City of Surrey
PLANNING & DEVELOPMENT REPORT

File: 7911-0053-00

Planning Report Date: June 27, 2011

PROPOSED SURREY HEALTHCARE CENTRE

DRAWING TITLE: PERSPECTIVE SKETCHES

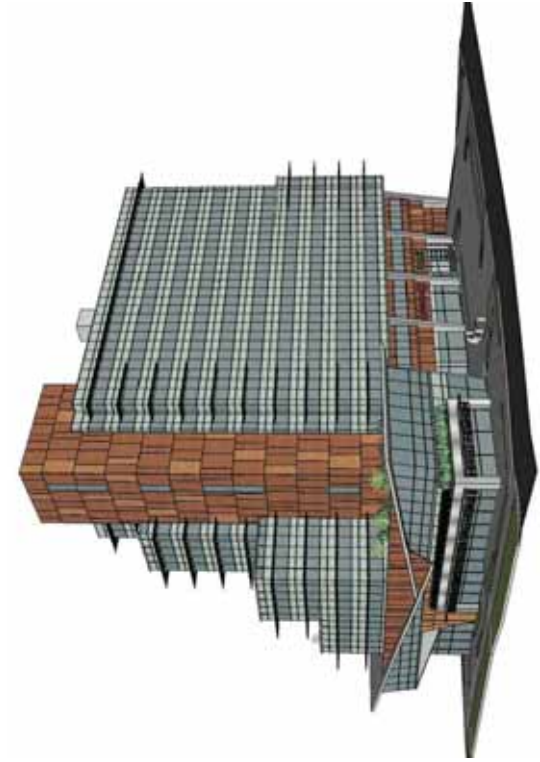
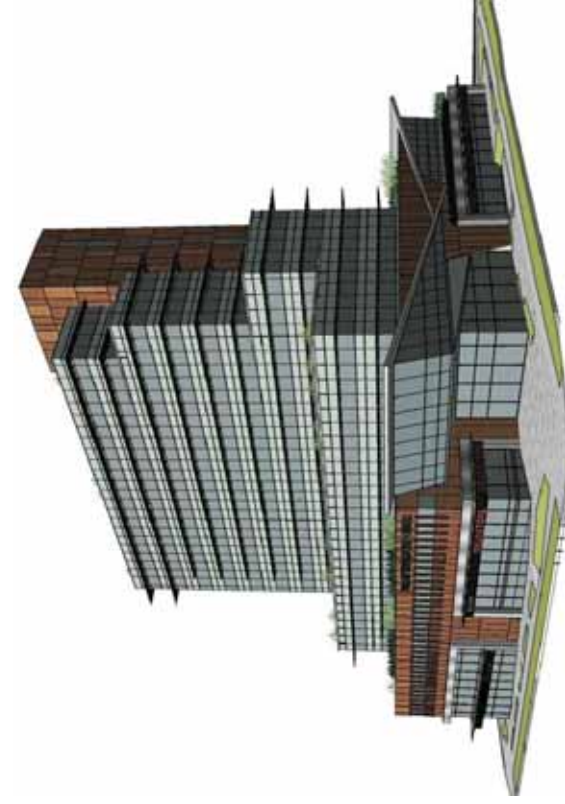
- Exit stairs with glass top and raked roofs don't deserve or warrant this type of celebratory treatment. Sloped roofs seem to be part of the language of the building. Could add windows into the stair well walls instead of roof.

(The glazing and sloped roof expression at the top of both east and west stair towers and narrow vertical windows have been added into both stair towers.)
